SUBJECT: NEW VEHICLE DEMONSTRATION / DELIVERY HOLD – *Supplement #3*
Safety Recall 20S73

Certain 2021 Model Year Econoline Equipped with 7.3L Engine
Engine Cover Thermal Management

New! REASON FOR THIS SUPPLEMENT

FIGURE 2

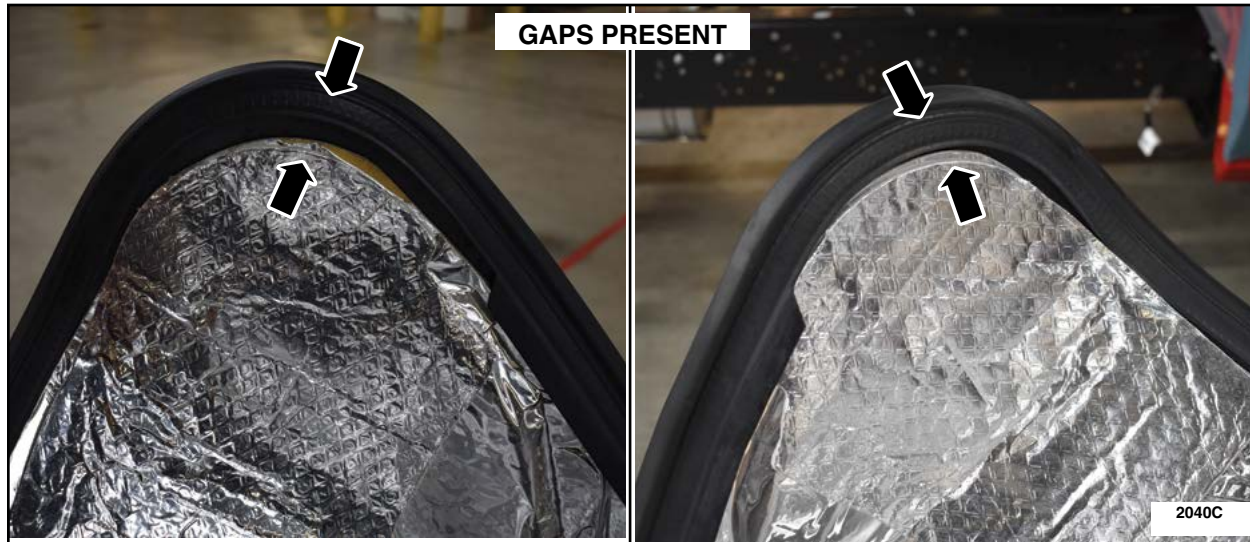
4. Are there any gaps present between the thermal shield and the engine covers weatherstrip on either side of the engine cover as shown in Figure 2?

YES - Proceed to the Thermal Patch Kit Installation Procedure.
NO - No further action is required.

FIGURE 3

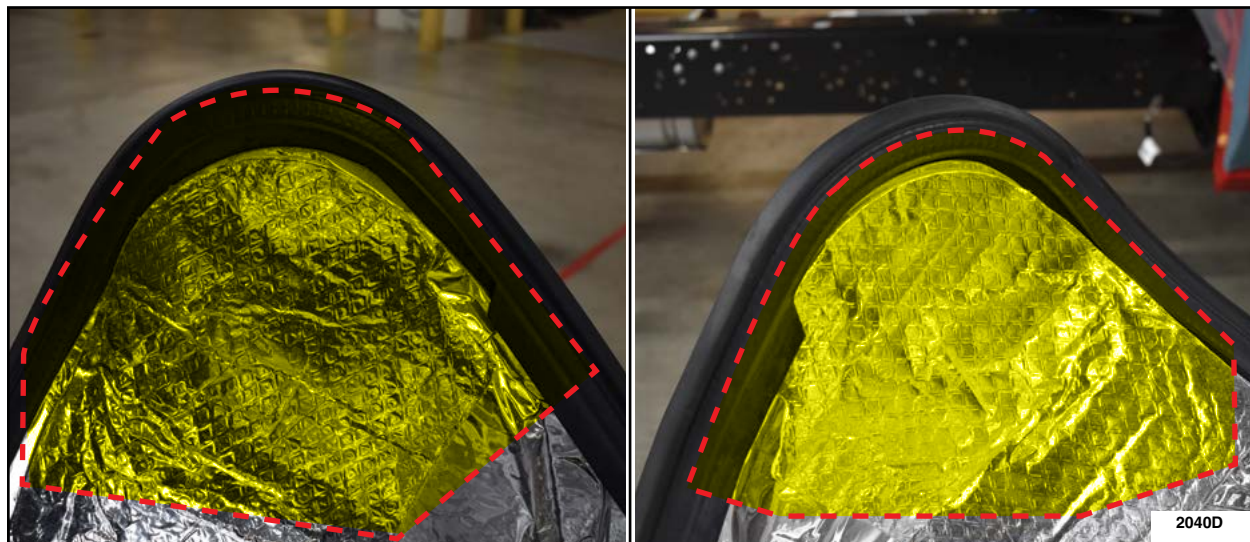
1. Clean the inside surface of the weatherstrip and the existing thermal shield with isopropyl alcohol and a clean shop cloth. See Figure 3.
